**TOWN OF NEWBURGH
PLANNING BOARD
TECHNICAL REVIEW COMMENTS**

PROJECT NAME: DRIVANOS- 2 LOT SUBDIVISION/LOT LINE CHANGE
PROJECT NO.: 2024-09
PROJECT LOCATION: SECTION 2, BLOCK 1, LOT 14 & 15
REVIEW DATE: 12 JULY 2024
MEETING DATE: 18 JULY 2024
PROJECT REPRESENTATIVE: ZEN CONSULTANTS

June 23, 2024

Drivanos Subdivision
SBL: 2-1-(14&15)

SITE PLAN
1"=40"

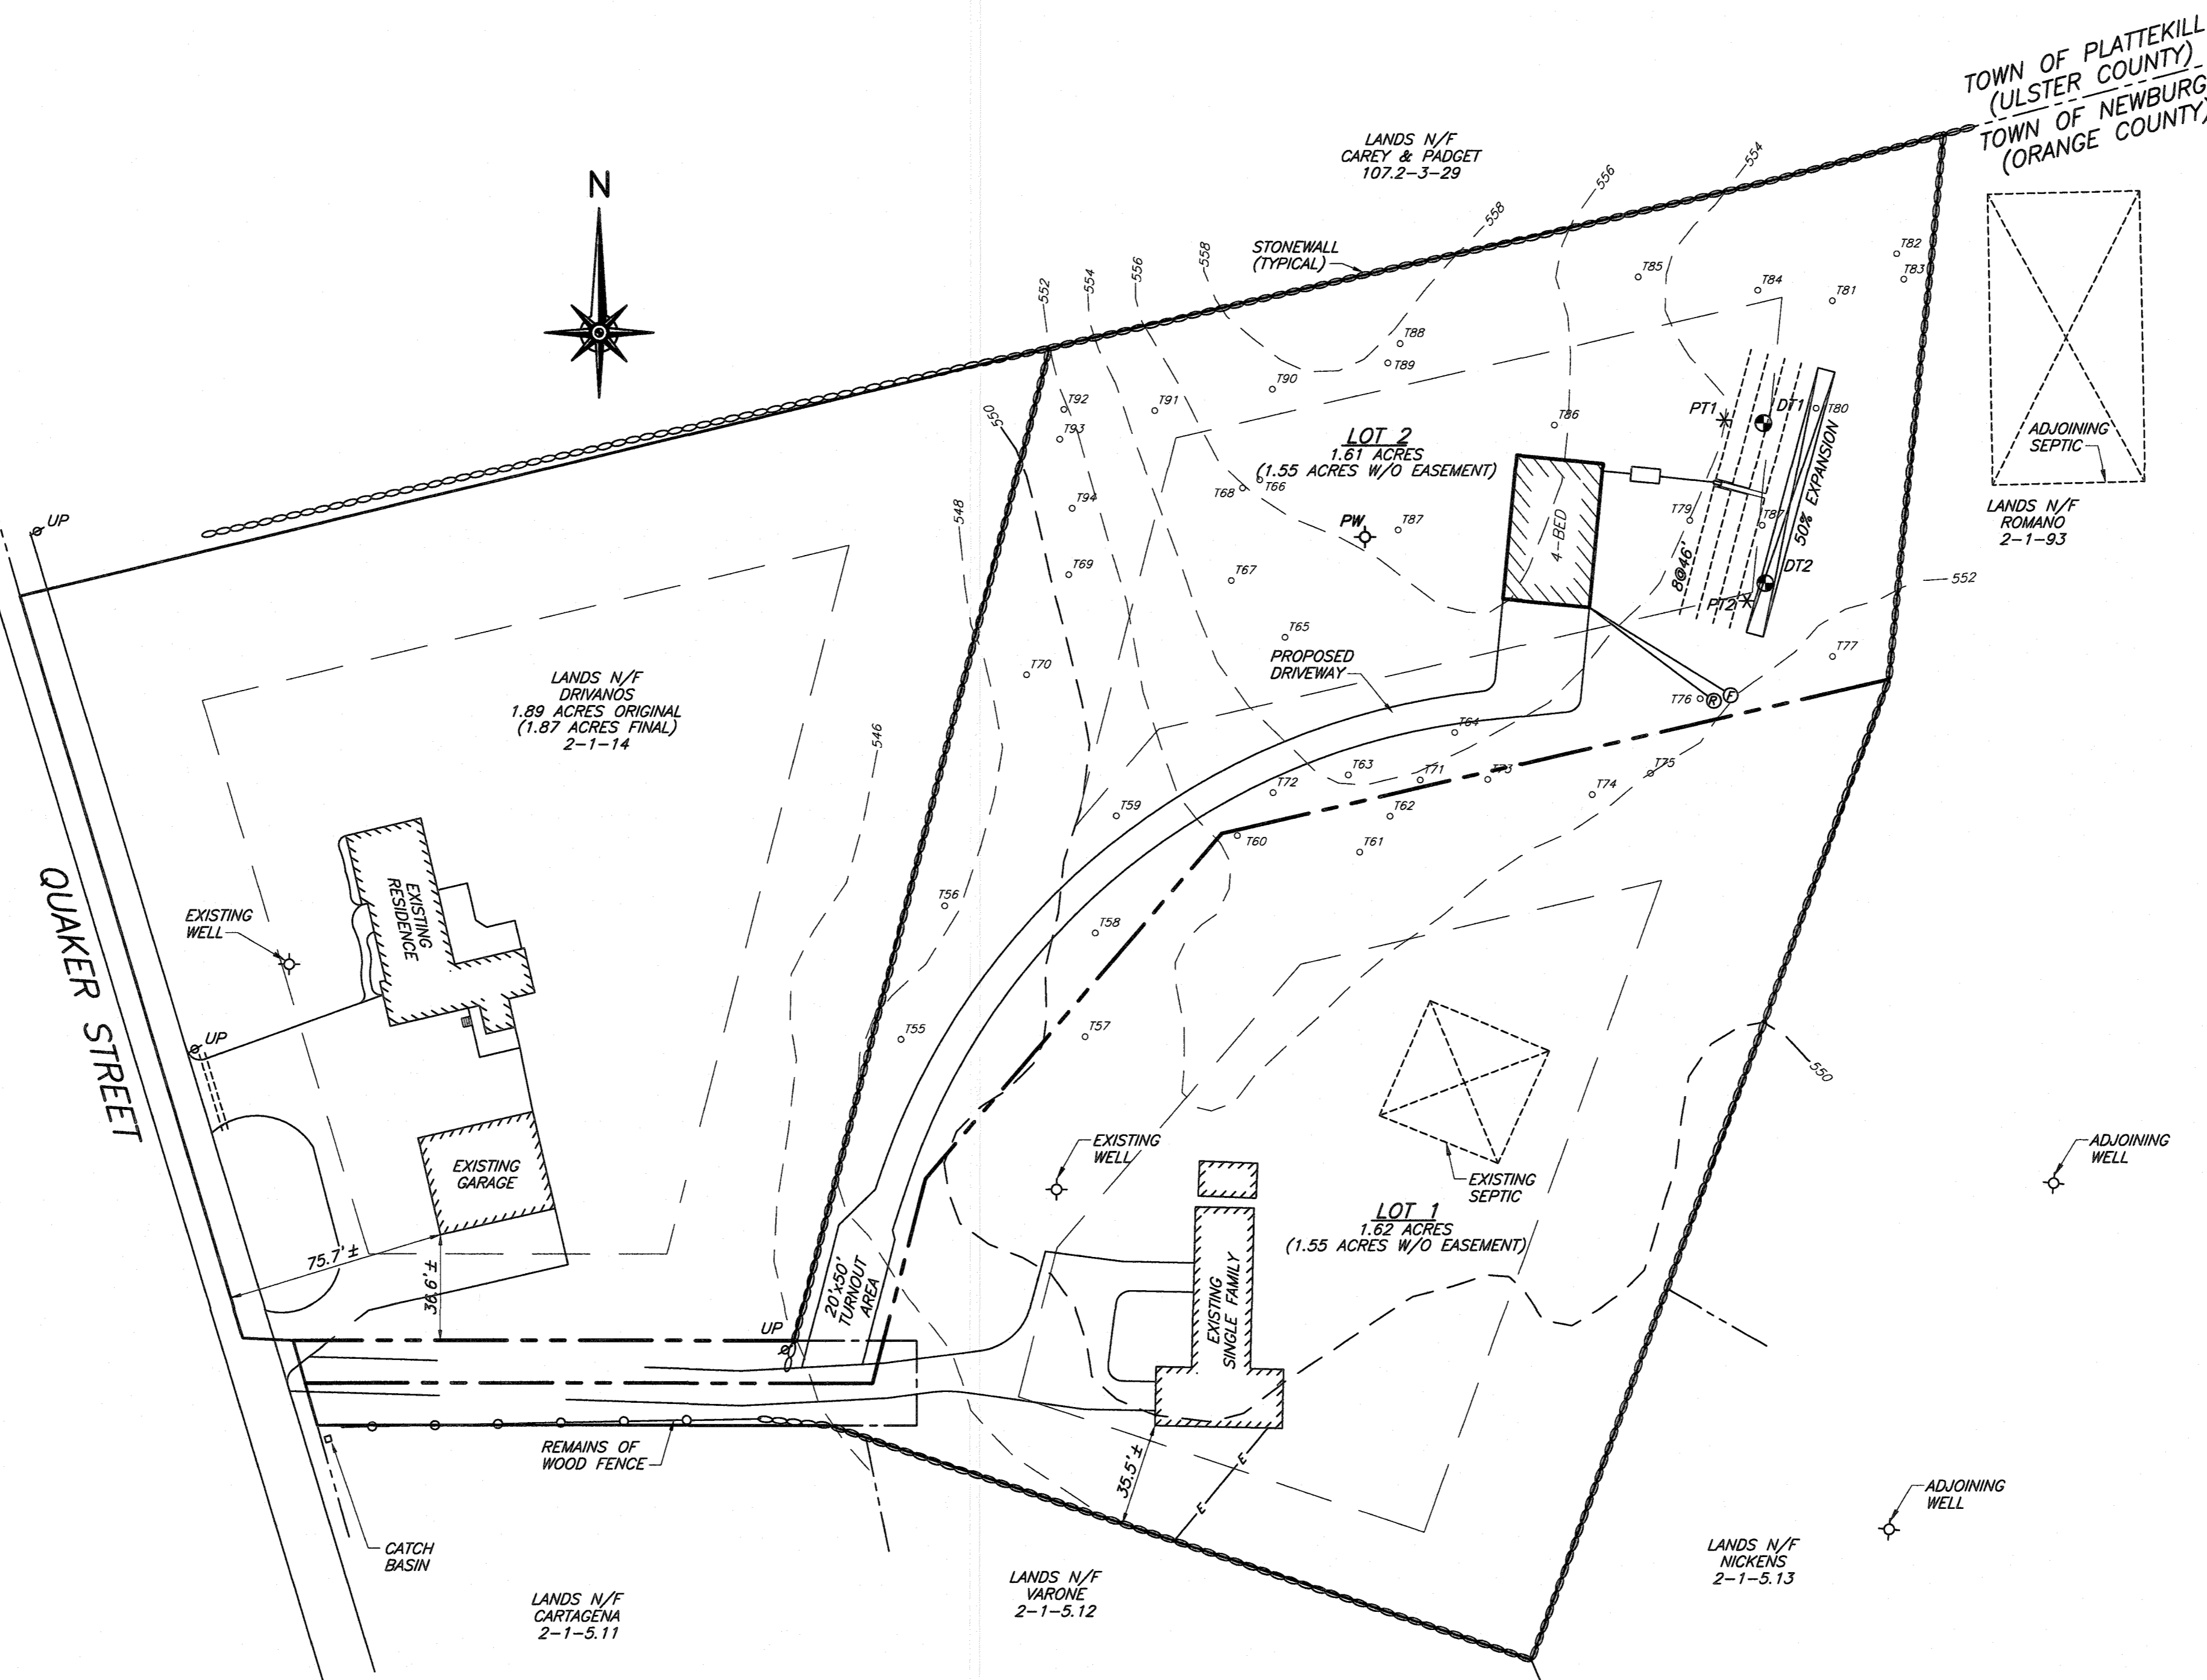
4. An enlarged section of the driveway has been proposed for emergency vehicle turning. Code Compliance comments on the size of the length and width of the turn-out should be received.

5. Compliance with the Town’s Tree Preservation Ordinance is required while a list of trees has been identified on proposed Lot #2, no indication as to the number of trees proposed to be removed within the limits of disturbance have been identified. Identify limits of disturbance with a Grading Plan including the number and type of trees to be removed must be identified. All types of trees must be identified based on the Tree Preservation regulation, protected significant and specimen tree. A chart should be developed identifying each and the number of each to be removed. This number can be used to calculate percentages permitted by the ordinance.

6. The length of the driveway serving lot #2 may require emergency vehicle turn outs. - *This has been added to the plan at the intersection of the driveway from lot #1 & #2. The site of the entrance to lot #2 driveway has been adjusted to accommodate this requirement.*
